# MEMORANDUM

**DATE:** NOVEMBER 28, 2019 **PROJECT:** 116132

**RE:** CLARIDGE / UNIFORM DEVELOPMENT (CU DEVELOPMENTS)  
SANITARY AND WATERMAIN SERVICING OPTIONS

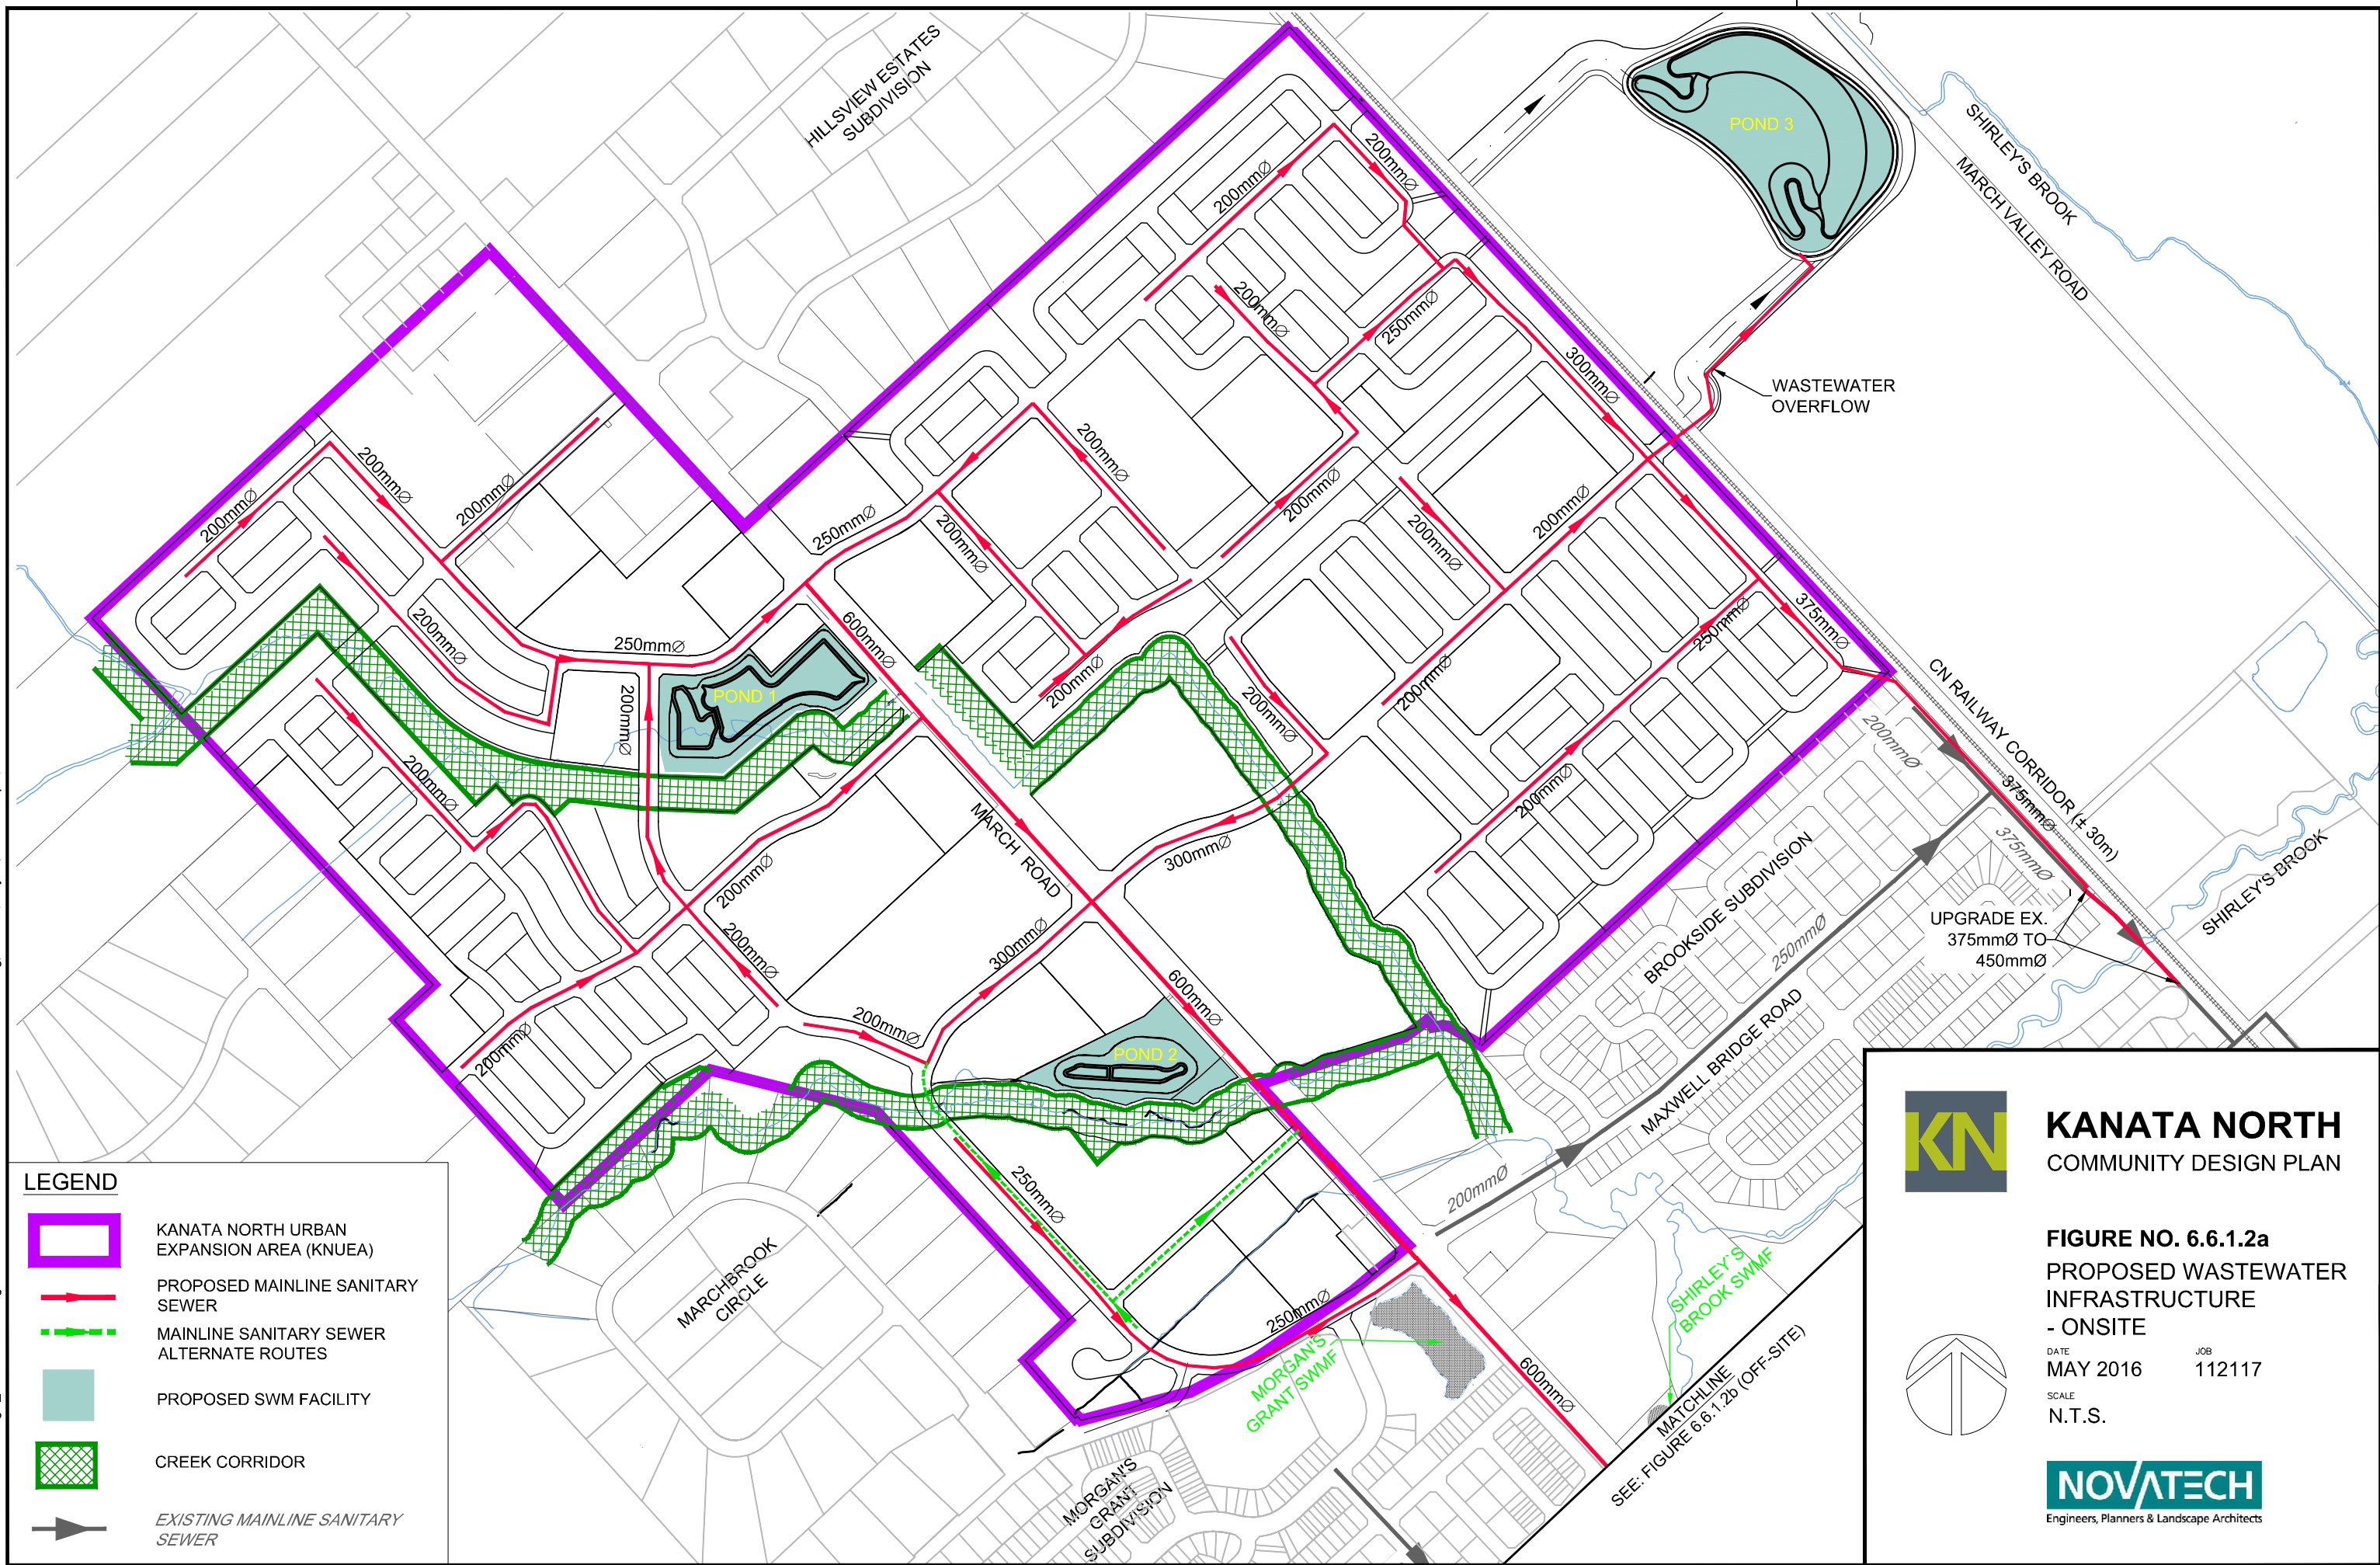
A significant concern I have regarding future storm and sanitary services routed through the park and ride parcel is how this may encumber our future ability to develop the parcel. As you are probably aware, during the CDP planning process there was significant concern expressed by the Infrastructure Approvals group (Ted Cooper and Darlene Conway) during their review of the MSS and EMP. During the planning for Kanata North, the consultant was well aware of the shallow depth of the bedrock in the area, grading and drainage issues related to this, and potential need and cost of excavation. Comment was provided regarding the grading of the Park and Ride (and Fire Hall) sites, and overall drainage in the northwest quadrant. During the development of the MSS or EMP, the need to extend services across the Park and Ride parcel was never identified. Given the challenges the City will encounter when the park and ride site is developed due to the underlying bedrock and drainage condition, the City/OC Transpo does not want to be further encumbered by storm/sanitary services extending across the site.

I'd like to understand why the developer is proposing extending services through the park and ride parcel. Is there a reason these services cannot be extended within the right-of-way of Street 1?

I am hoping you can help me out with a couple questions I have regarding a future park and ride parcel within the Kanata North Urban Expansion Area (1075 March Road). The consultant has proposed a future storm sewer and sanitary sewer to bisect the property from the north-west corner to the south-east corner, with a connection to Street 1 (see image below for reference and attached full scale drawing).

Do you foresee any major concerns with having this infrastructure (storm and sanitary sewers) located below the park and ride parcel?

My second question is regarding access to the park and ride. The consultant has proposed that access to the park and ride would be off of Street 1, at the turning circle seen in the image above. Would there be a need/want for an access directly off of March Road? Due to grading constraints, the current design may restrict an access off of March Road due to the proposed elevations within the park and ride block and the existing grades on March Road.

The reason why the future storm and sanitary sewers have not be routed to Street 1 is due to the shallow bedrock in the area and the significant amount of additional bedrock removal that would be required to capture drainage from the future development lands adjacent March Road. Constructing the sewers through the Park and Ride represents the 'most direct route' to provide servicing for the lands west of March Road. That said, as part of our comments to Novatech, we have asked them to demonstrate that the future development parcels west of March Road (north of the Park and Ride) could be servicing via sanitary and storm sewers on March Road, which would in turn eliminate the need for the bisecting sewers through the Park and Ride.

**FIGURE NO. 6.6.1.2a**  
**PROPOSED WASTEWATER INFRASTRUCTURE - ONSITE**

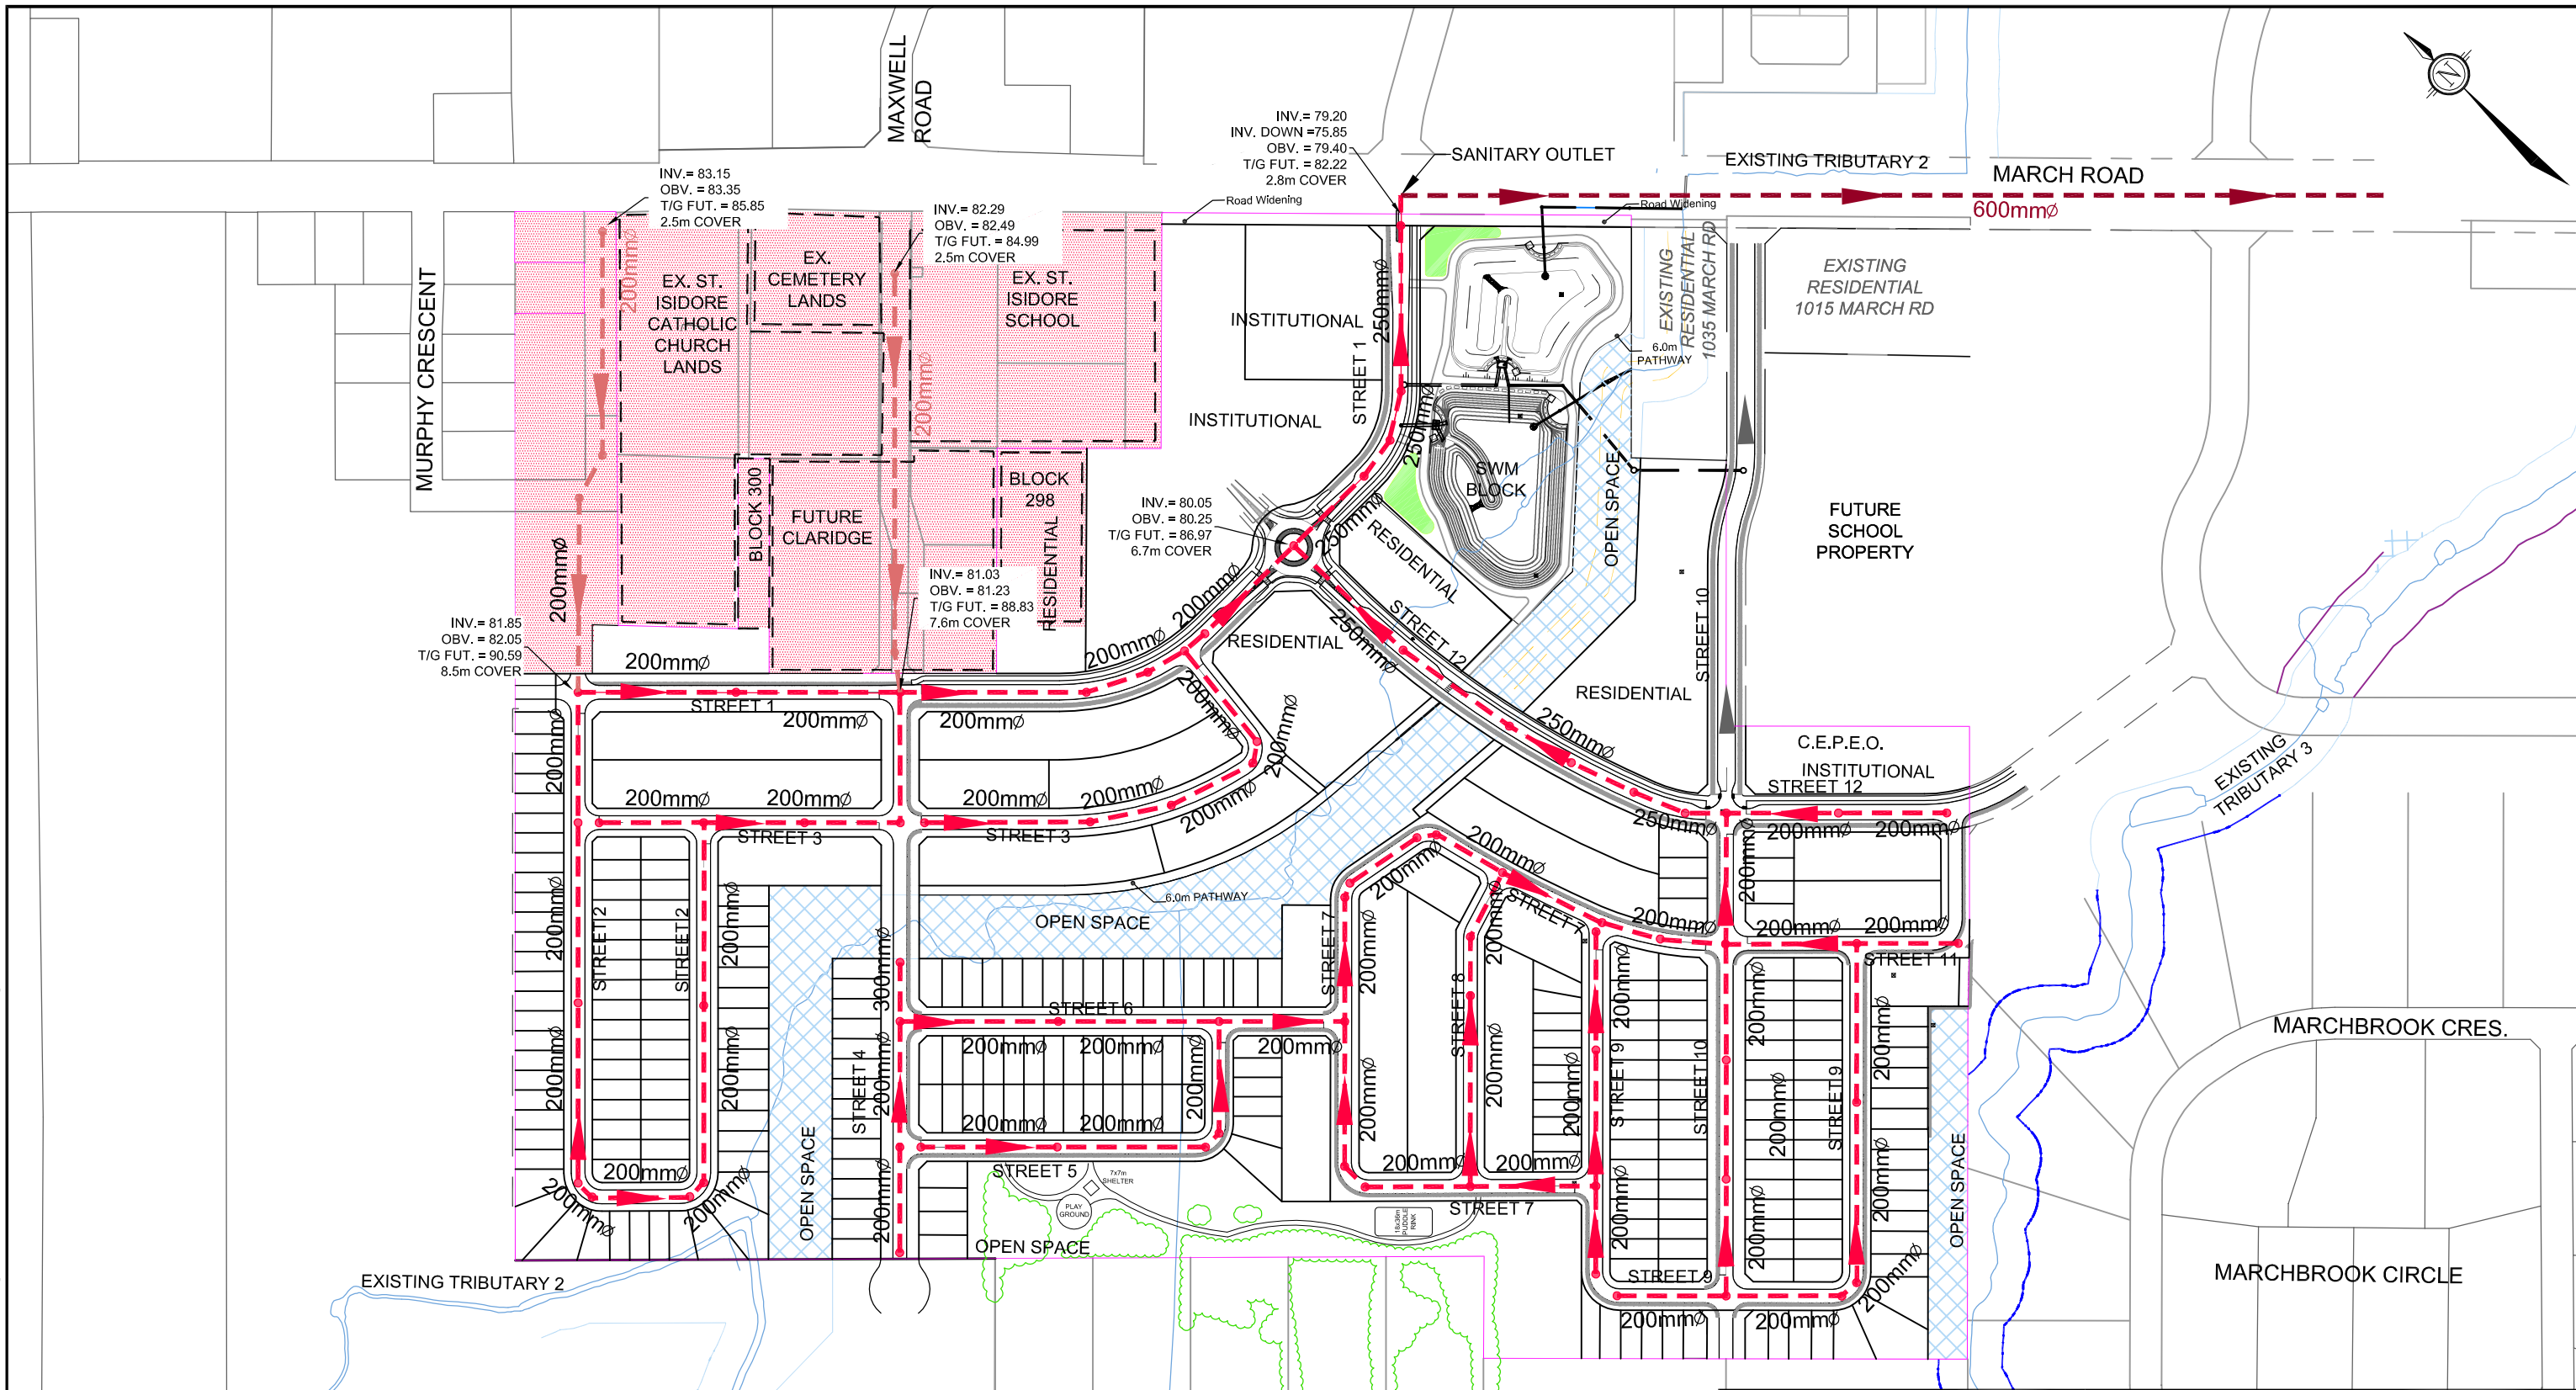
The Kanata North Urban Expansion Area (KNUEA) Master Servicing Study (MSS) identified that the sanitary service option was to convey flows east to west, connecting into the Street 1 sewer. Refer to attached Figure 6.6.1.2a – Proposed Wastewater Infrastructure.

The existing topography slopes west to east with a drop in elevation of approximately 5.0m from Street 1, through the existing / future lands, to March Road. Directing the sanitary flows in a westerly direction results in a sanitary sewer depth of 7.0-8.5m at Street 1. This sanitary approach also forces the sanitary sewer on Street 1 to be at depths of 6.0-8.5m to the March Road connection.
